Before the Board of Inquiry  
Waterview Connection Project

Rebuttal evidence of **André Walter (Construction)** on behalf of the  
**NZ Transport Agency**

Dated: 3 February 2011

Title: LONG SECTIONS SH20  
NORTHBOUND SHEET 3

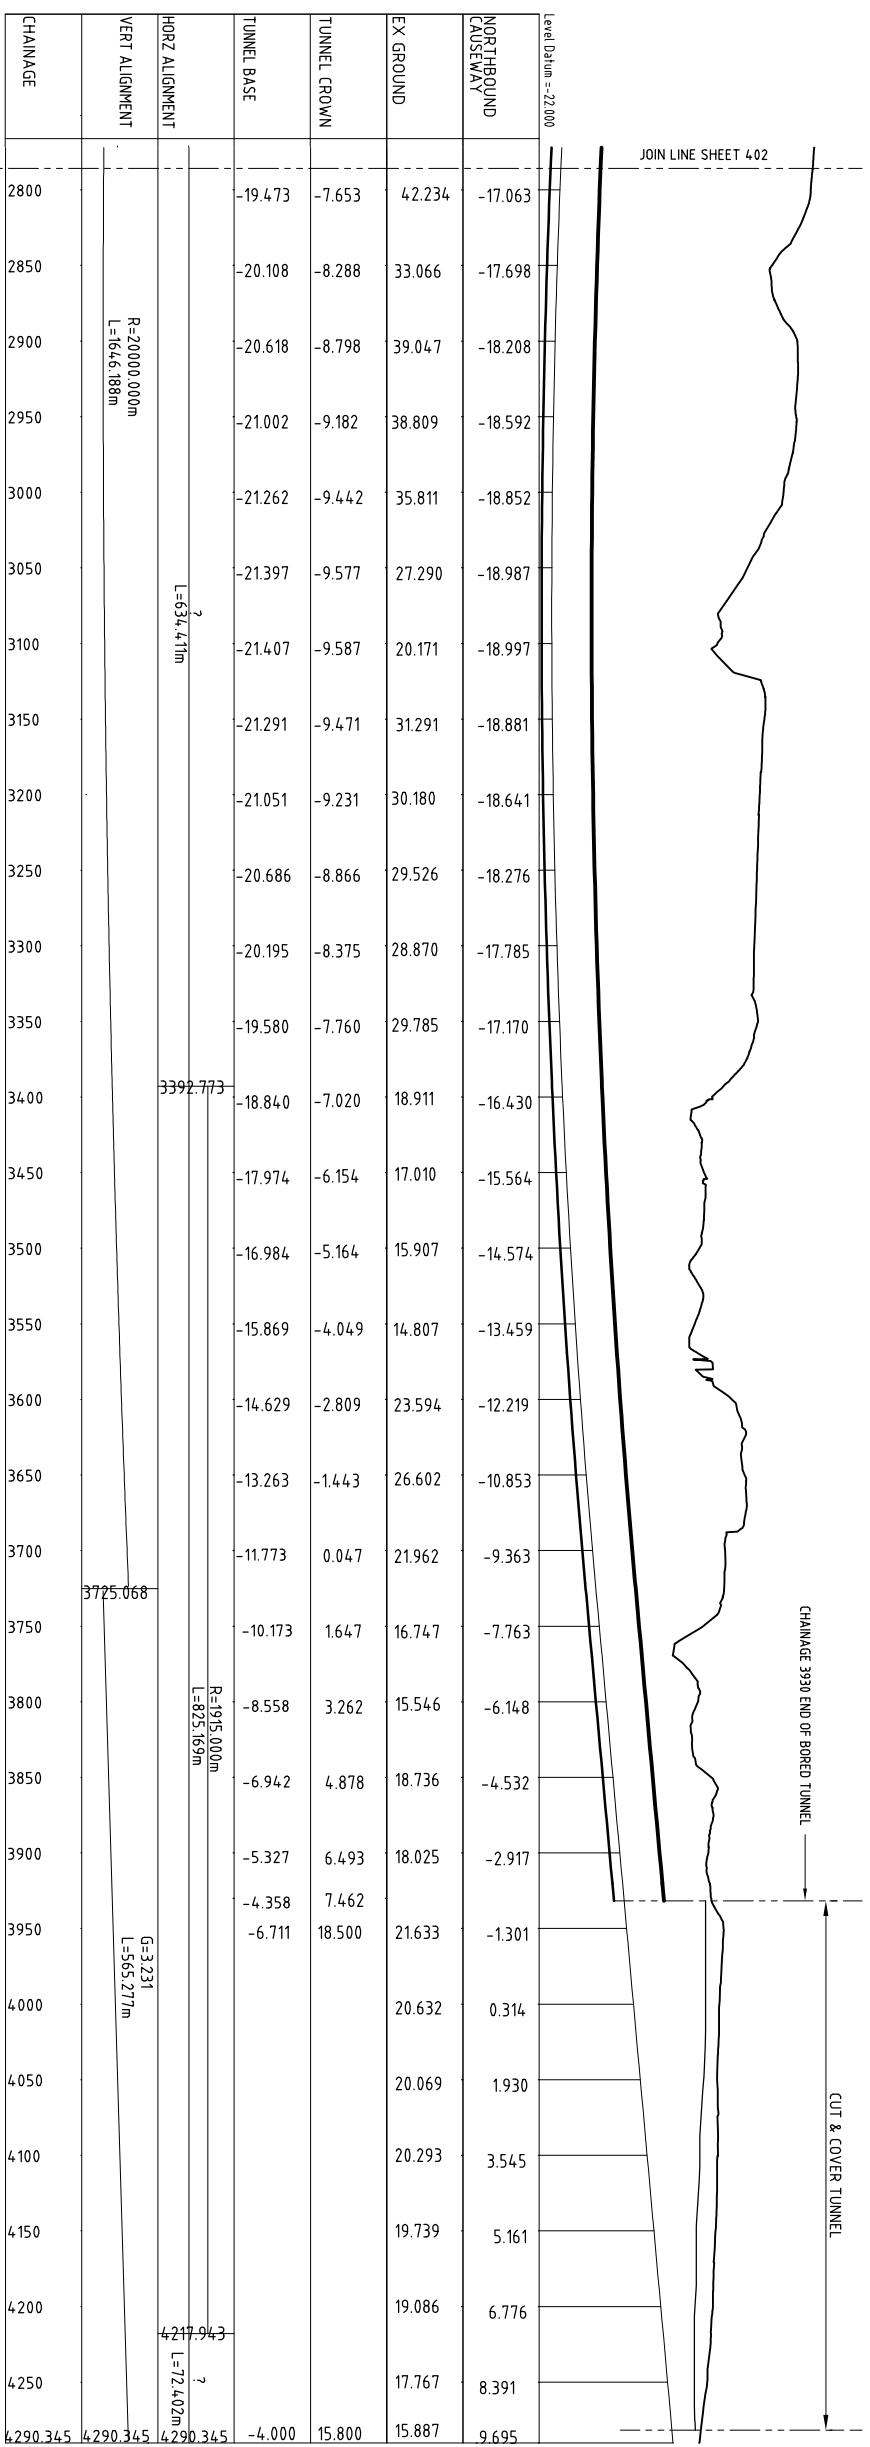
- 71 The vertical alignment of the Project within this section is shown in Drawing 20.1.11-3-D-C-102-403 included as **Annexure L**. At Location 2, the tunnel portal would then be approximately 21m below natural ground level.

**ANNEXURE N: PLANS SHOWING CHANGES TO THE VENTILATION  
BUILDING LAYOUTS**

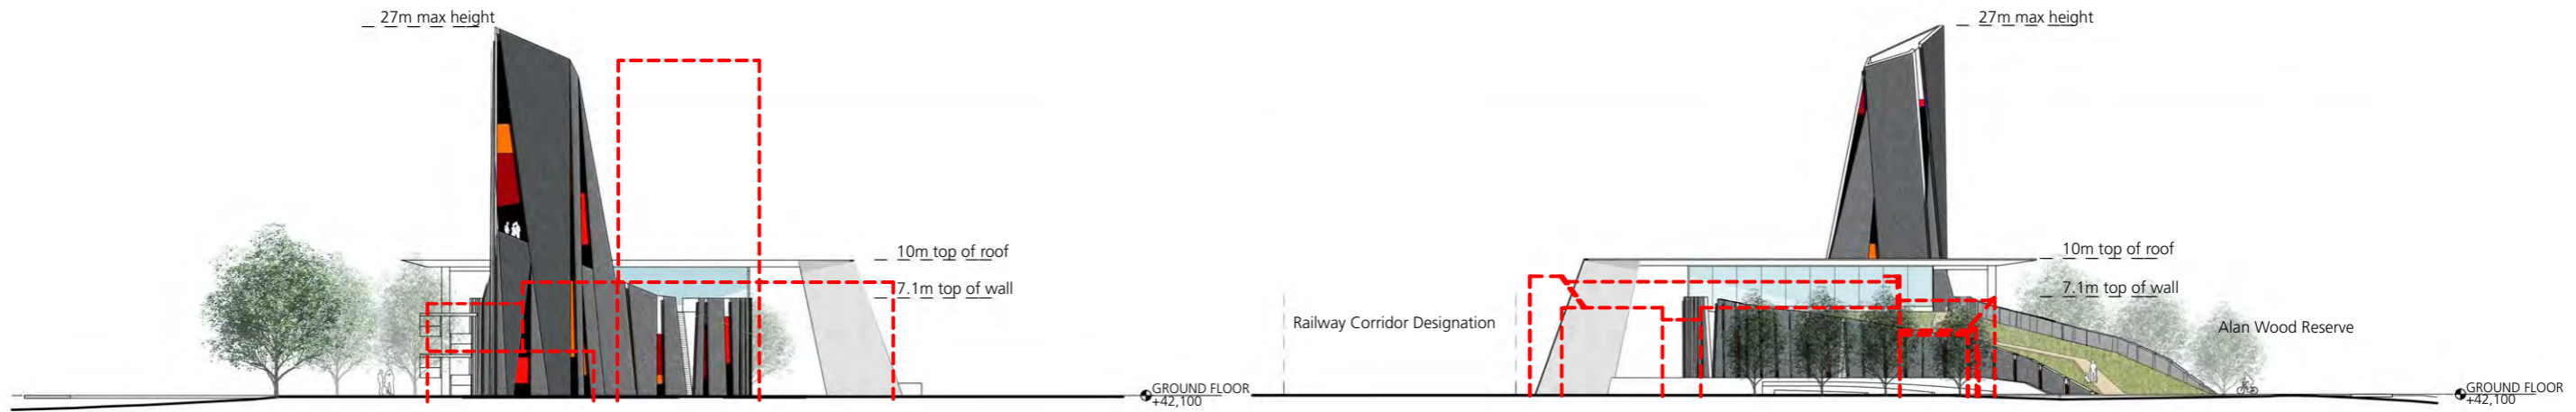
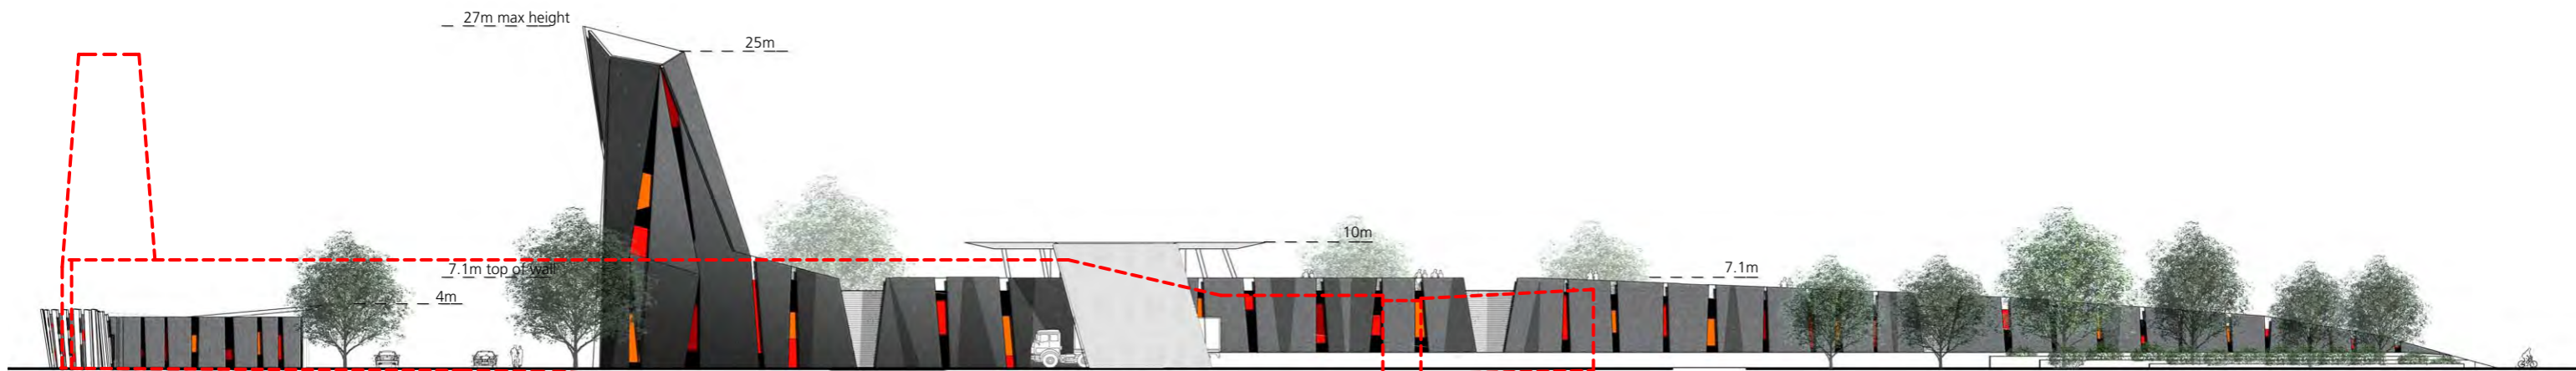
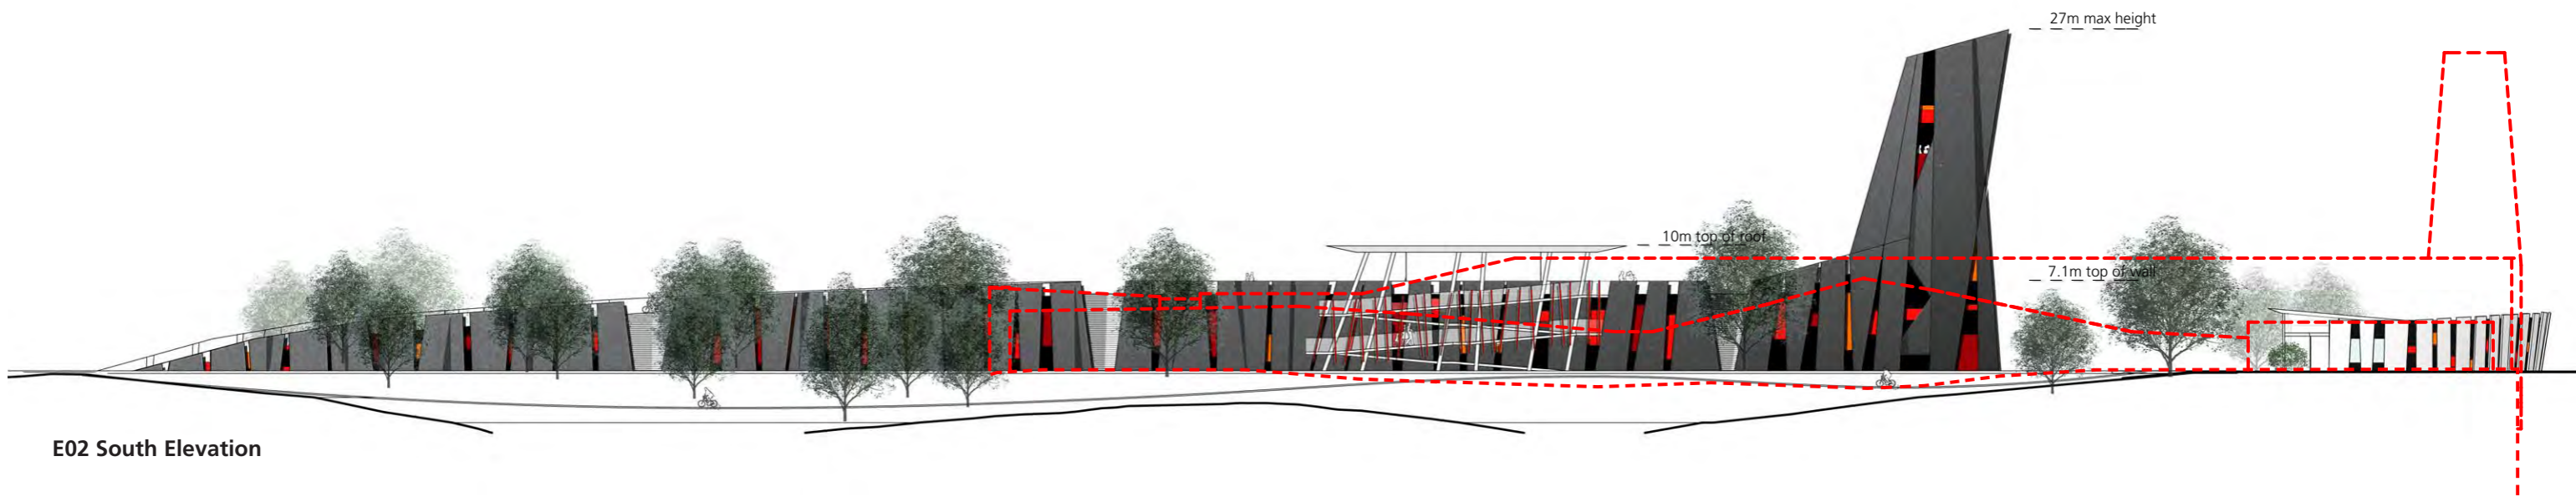
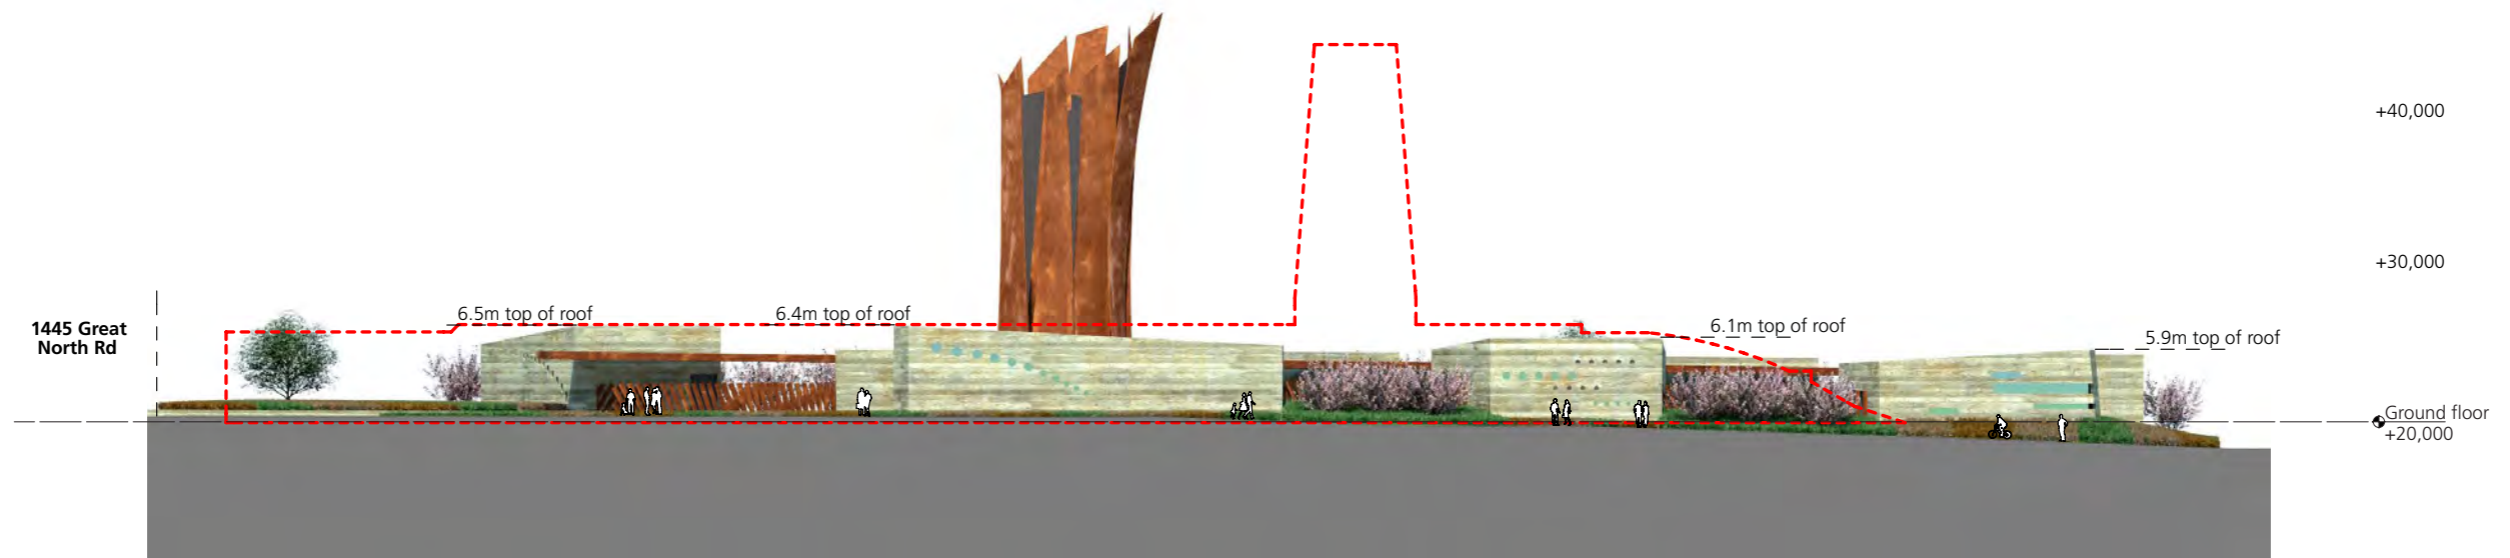
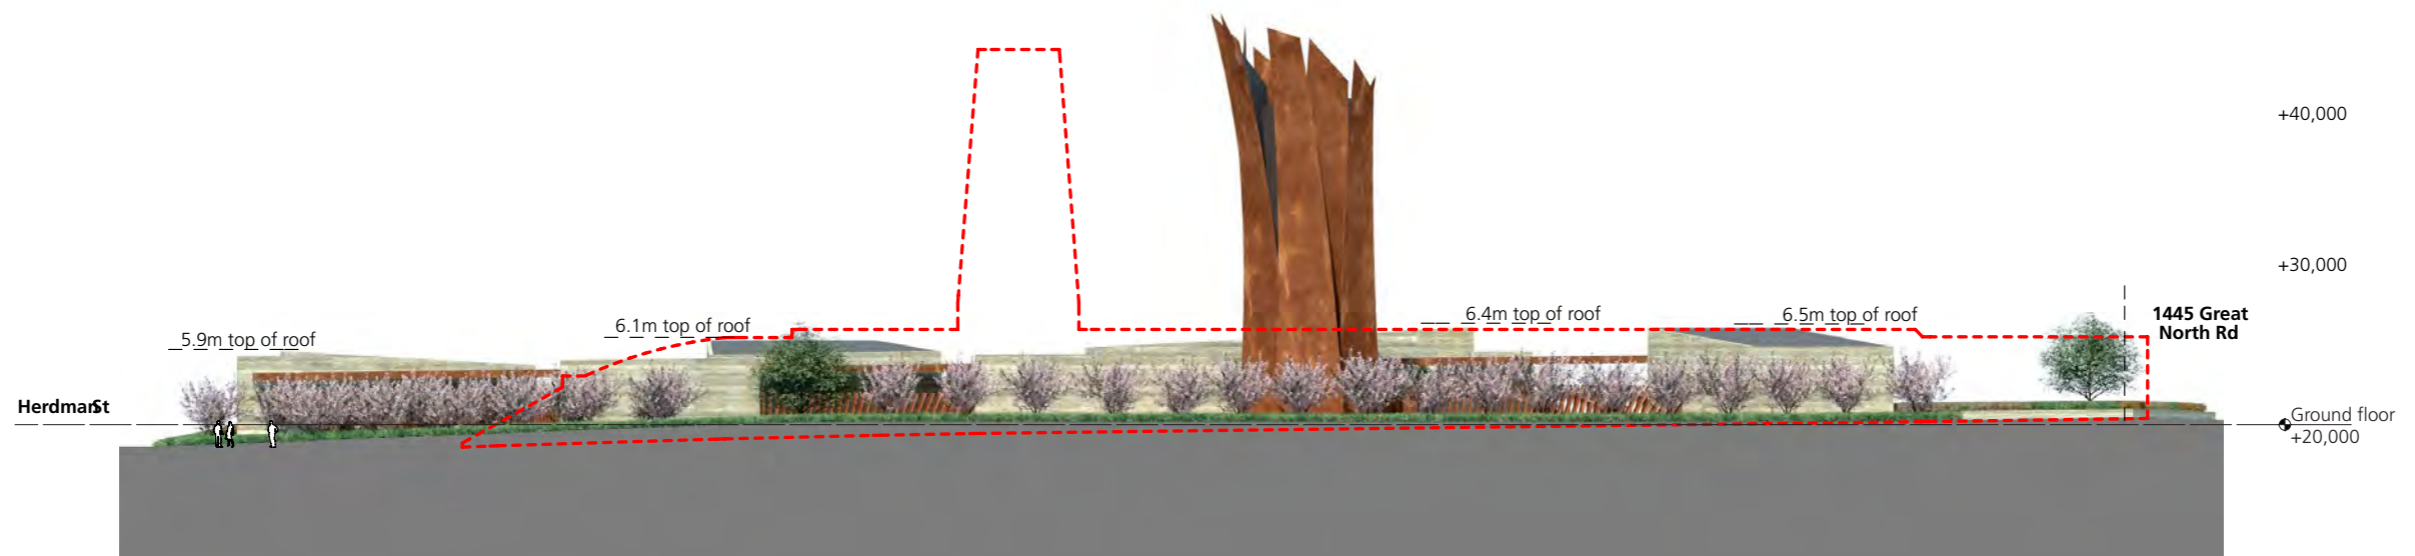
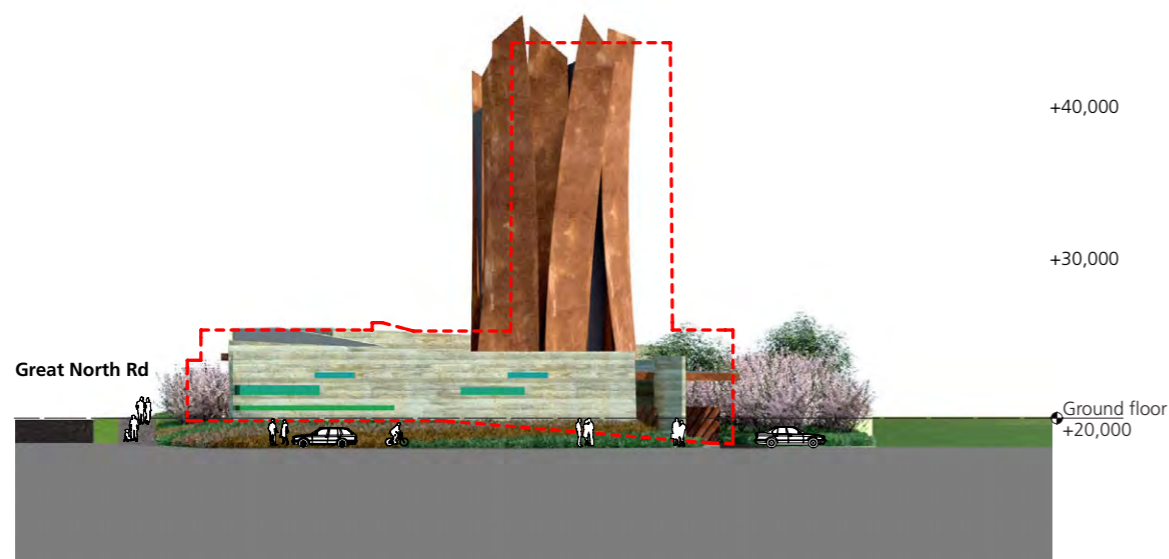
- 102.2 Additional design and assessment has been undertaken regarding the ventilation buildings and stacks at the northern and southern portals to the tunnel. As discussed in my EIC, this has resulted in the operational buildings originally proposed in the Northern Ventilation building to be relocated to the Southern Ventilation building. This has allowed the Northern Building footprint to be reduced in size. This is shown on the Plans showing changes to the Ventilation Building Layouts attached as **Annexure N**.
